Reference: P0898-2

Subject: 93 Bridge Road, Westmead – Response to traffic and transport related submissions on SSDA (SSD-80904224)

Appendix A Swept path assessment

DOCUMENT INFORMATION
Swept Path Analysis
Basement 1 - Car Space 10 - Entry & Exit
FILE NAME AG0898-2-d01-v06.dwg
SHEET AG_SP01

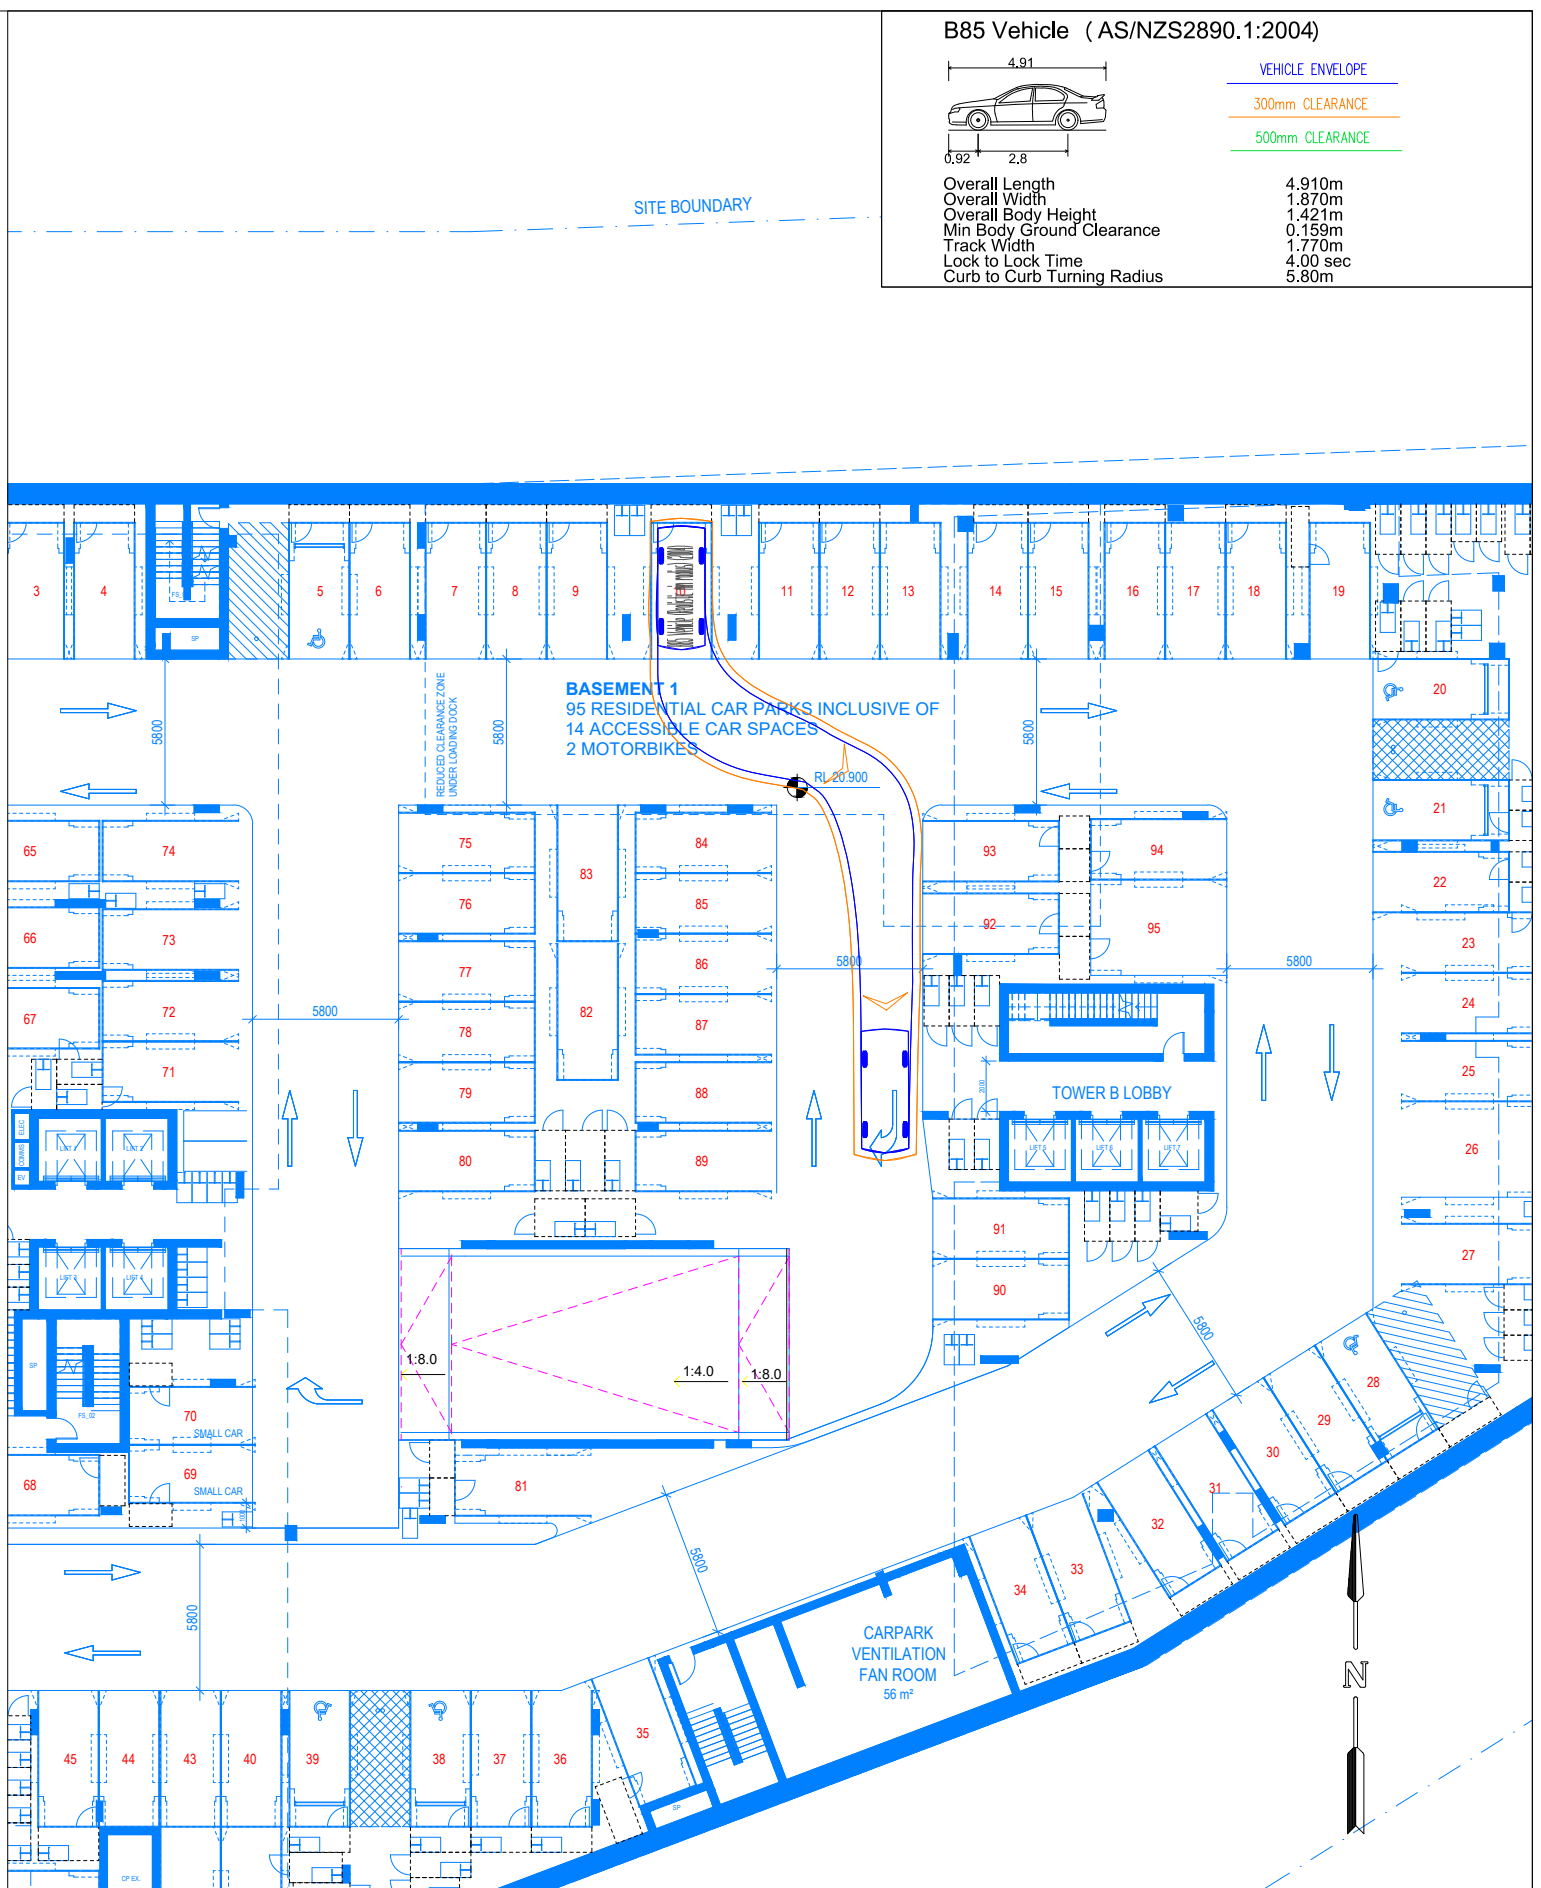
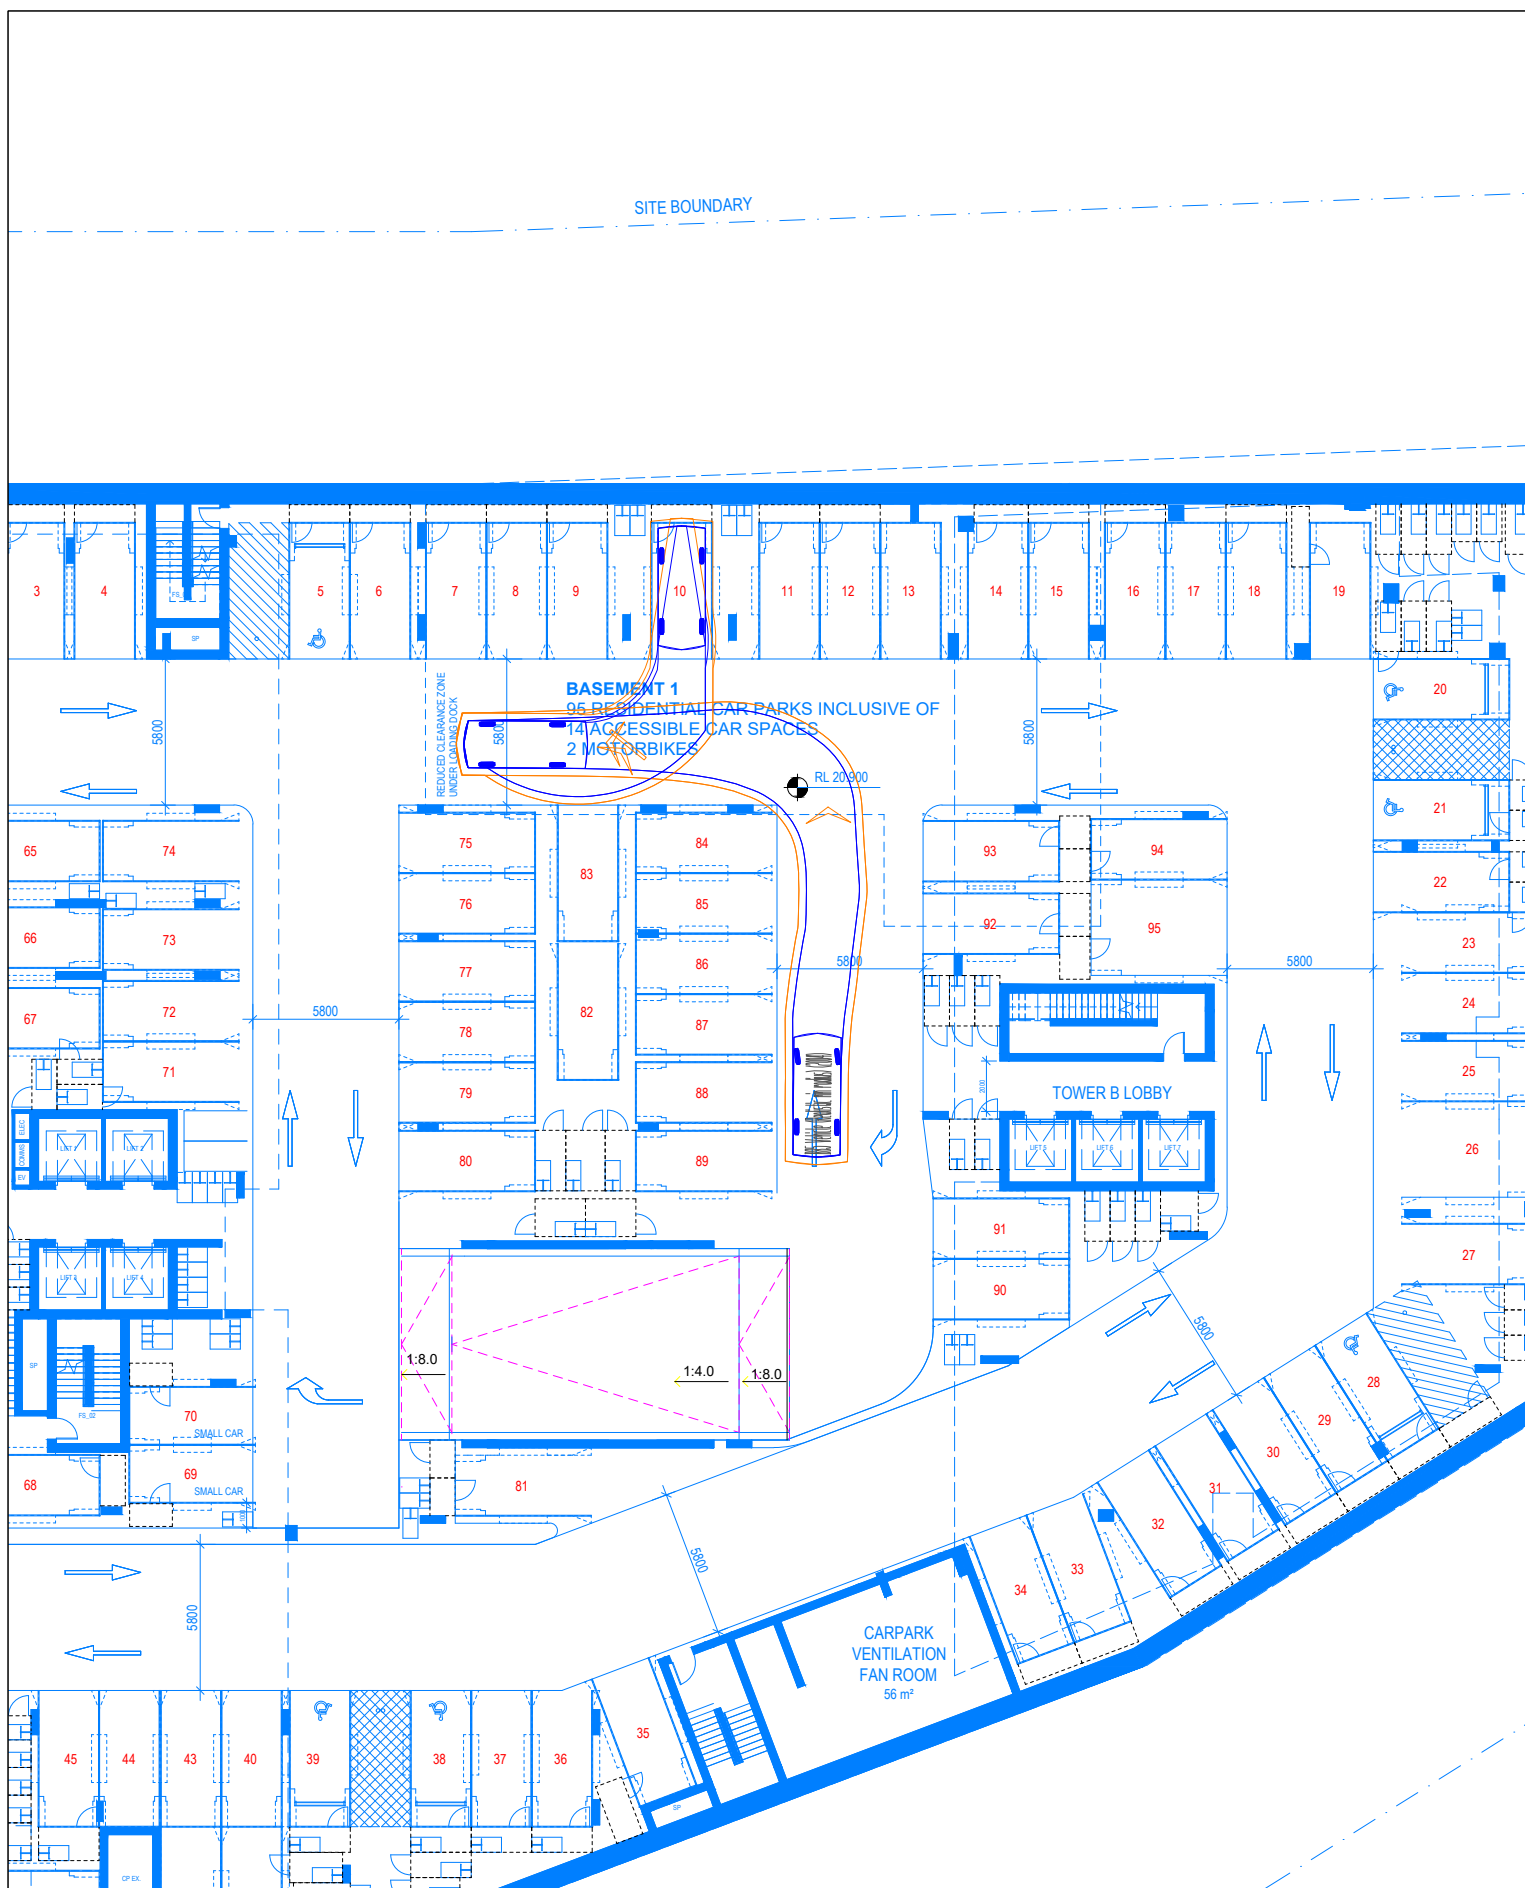
Comment: *Parking spaces adjacent to columns in the basement may obstruct access, reducing aisle widths. Aisle widths must meet Australian Standards, or swept paths should be demonstrated to show that access to spaces can be made with an acceptable number of manoeuvres. Bicycle parking spaces should also be allocated to the same unit to avoid accessibility issues. Standards require the grade for at least 6m prior to the control point to not exceed 5%. However, the 5% grade is only provided for 3m prior to the control point.*

Response: The car parking layout has been designed in accordance with AS/NZS 2890.1:2004 and is subject to further design development as part of detailed design. Spaces and aisles are generally compliant with AS/NZS 2890.1:2004 with respect to the user class. Although certain locations have columns positioned the standard 5.8 metres behind parking spaces instead of the increased 6.1 metres to high structure, constituting a technical non-compliance, these columns represent localised obstructions as opposed to continuous walls and do not materially impact access to the car parking spaces on the opposite side of the aisle. Swept paths are provided in Appendix A confirming suitable access to these spaces is achievable.
